# SCDOT

*Value Engineering Study*

**I-73 Southern Section  
Right-of-Way Plans**

Southbound Ramp

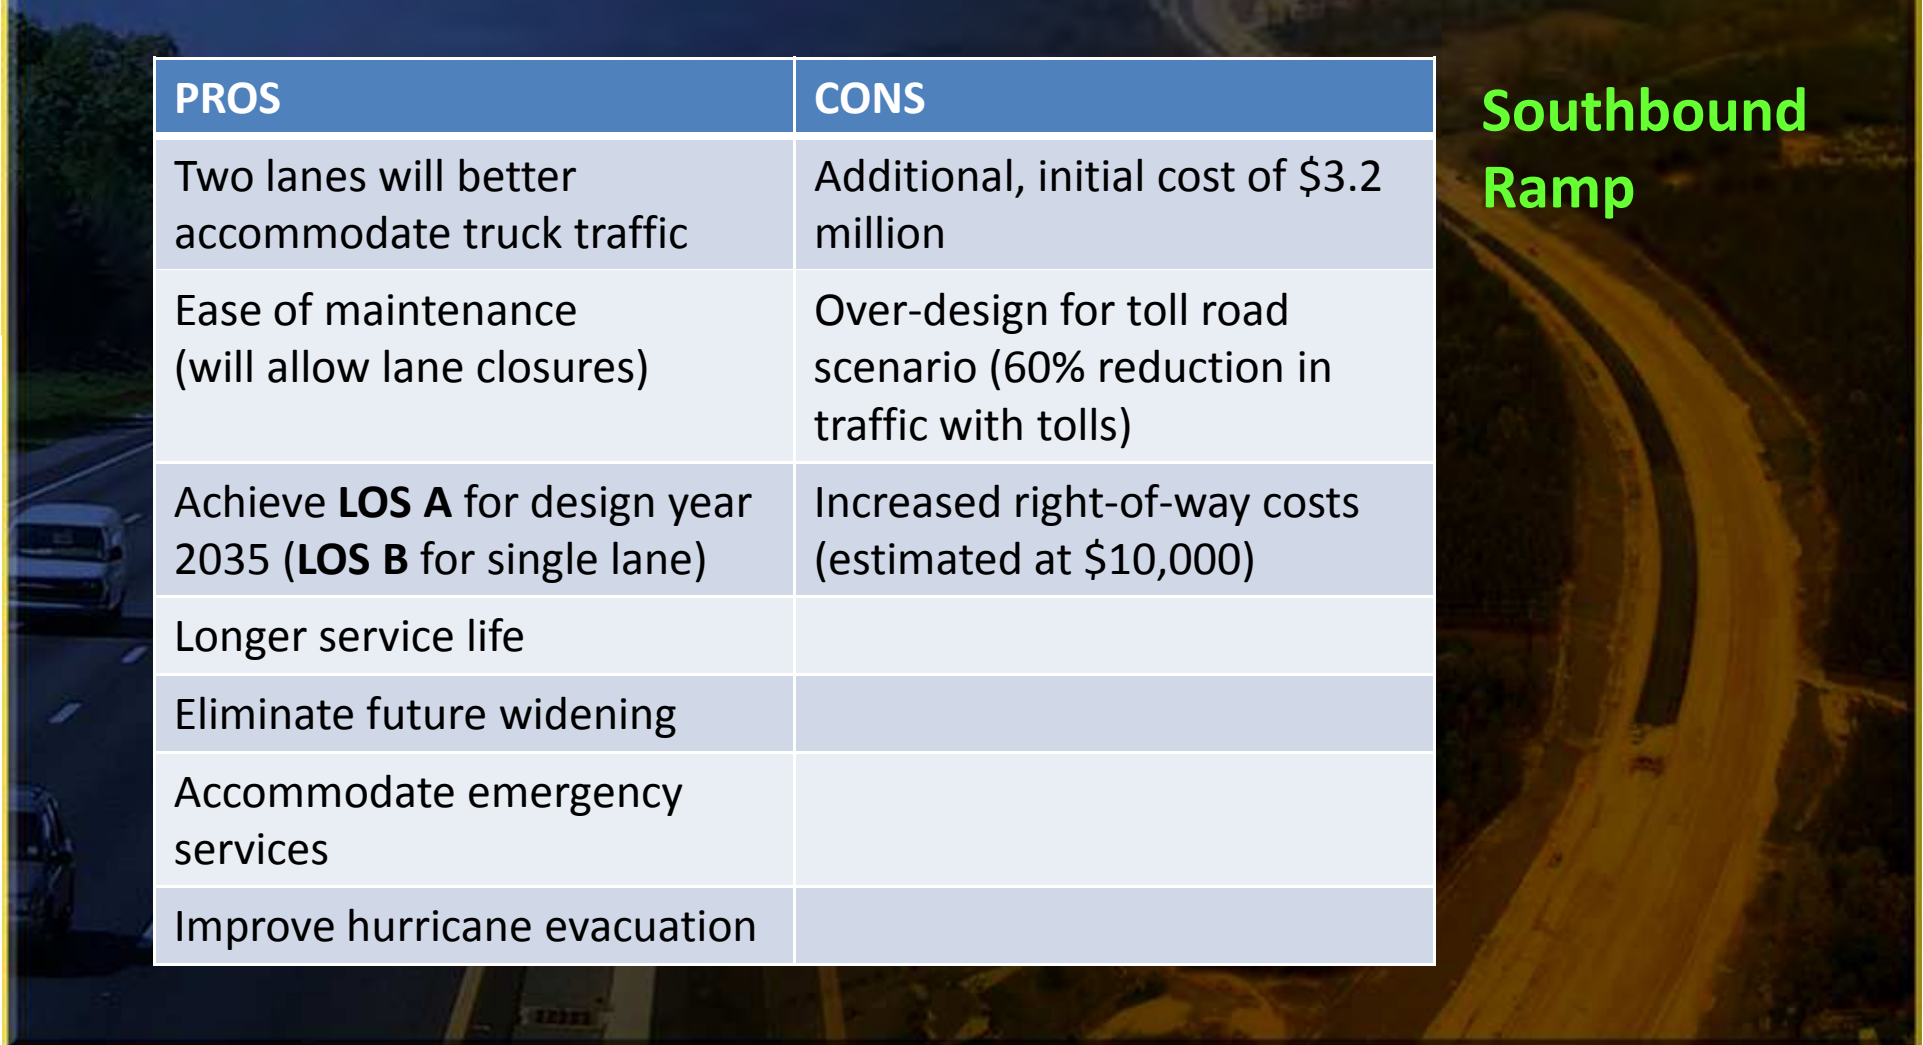
I-95/I-73 Interchange: Widen the two main interchange ramps from one, 16' lane to two, 12' lanes.

PROS	CONS
Two lanes will better accommodate truck traffic	Additional, initial cost of \$3.2 million
Ease of maintenance (will allow lane closures)	Over-design for toll road scenario (60% reduction in traffic with tolls)
Achieve <b>LOS A</b> for design year 2035 ( <b>LOS B</b> for single lane)	Increased right-of-way costs (estimated at \$10,000)
Longer service life	
Eliminate future widening	
Accommodate emergency services	
Improve hurricane evacuation

I-73/SC 22 Interchange: Original Directional Interchange

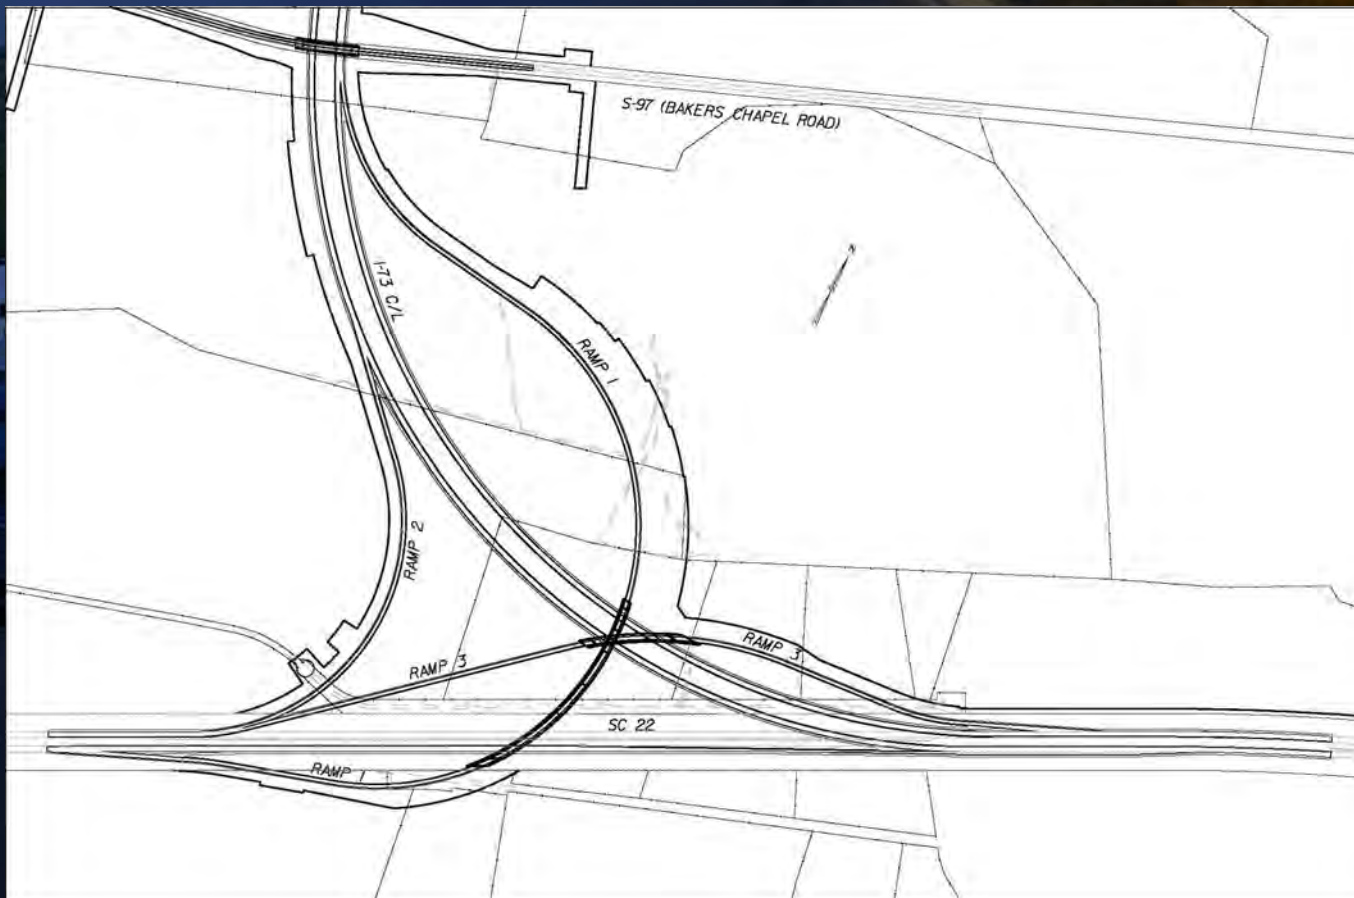
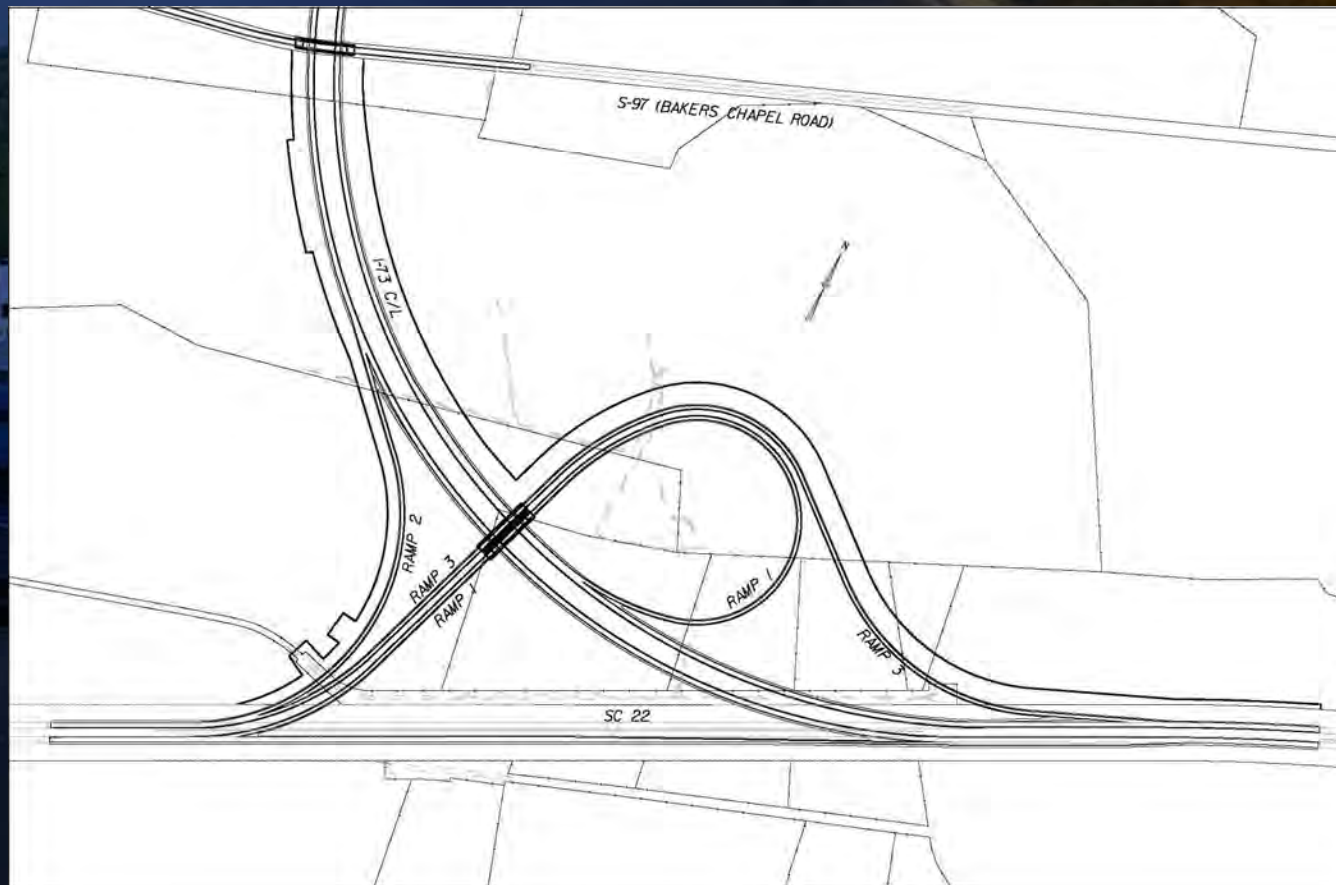
I-73 adjoins SC 22 just east of the SC 22/SC319 interchange and will continue eastward towards Conway. The VE Study Team discussed the possibility of revising the I-73/SC 22 Interchange to a one-lane or two-lane trumpet design instead of a system-to-system directional interchange. The VE Study Team requested that the Design Team evaluate the possibility of using a compound curvature for the loop ramp.

PROS	CONS
Reduce ramp fill heights and bridge requirements for a cost savings estimated at \$31.1 million	Safety issues with loop design
Lessen length of Bakers Chapel Road crossing bridge (end acceleration lane prior to crossing under the Bakers Chapel Road bridge)	Two of the four ramps will have reduced (60-40-60 mph) design speeds – directional ramps are all 55 mph
No conflict with hurricane evacuation	May require reopening the EIS to assess impacts
Handle estimated volumes at design year (with projected SELL project volumes)

I-73/SC 22  
Interchange:  
Revise current  
three-level,  
multiple structure  
interchange to a  
T-type, trumpet  
design.

I-73/SC 22 Interchange: Proposed option, one-lane trumpet interchange.

### Interchange at S308:

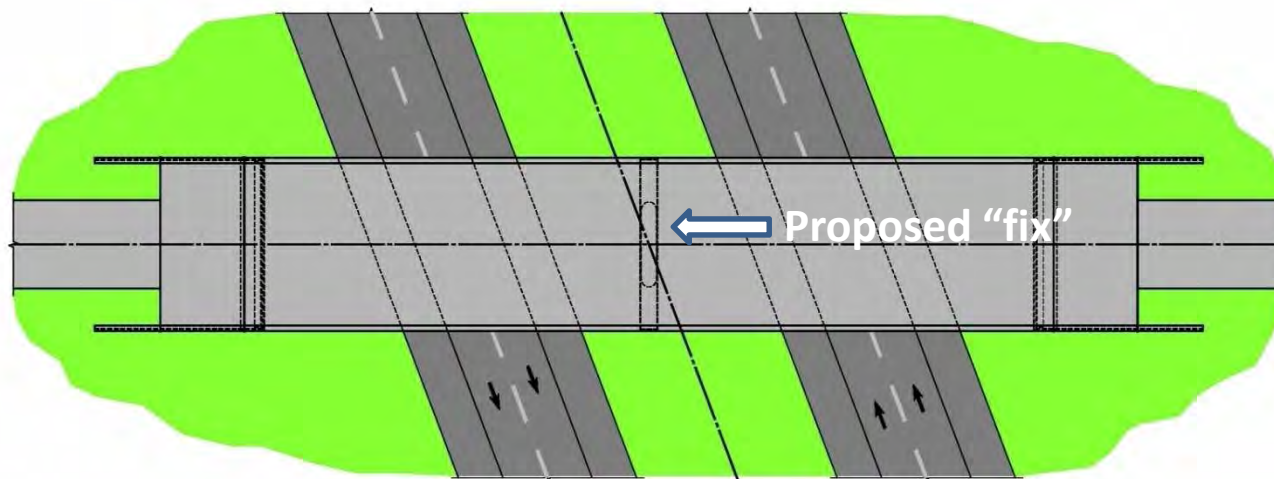
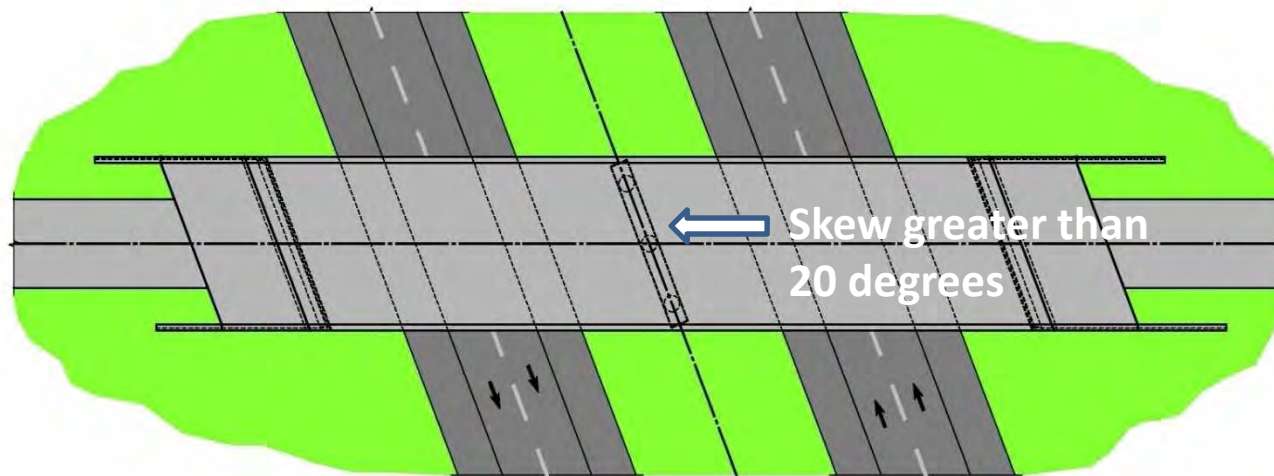
The VE Study Team asked the Design Team to provide justification for the S308 interchange and for the location chosen for that interchange.

- ▶ Without the S308 interchange, there was no access between US 701 and US 76 interchange, a distance of over 25 miles.
- ▶ Other potential locations are at S23 (South Nichols Highway) or S99 (Lake Swamp Road). The communities at S23 and S99 did not want the interchange at those locations, fearing an interchange would alter the character of the community.
- ▶ There would be additional relocation impacts at either S23 or S99.
- ▶ Ketchup Town, located on S99, is considered to be a local landmark and would be impacted significantly by the interchange.
- ▶ Horry County requested the S308 location for the interchange to provide more direct access to the Cool Springs Industrial Park.
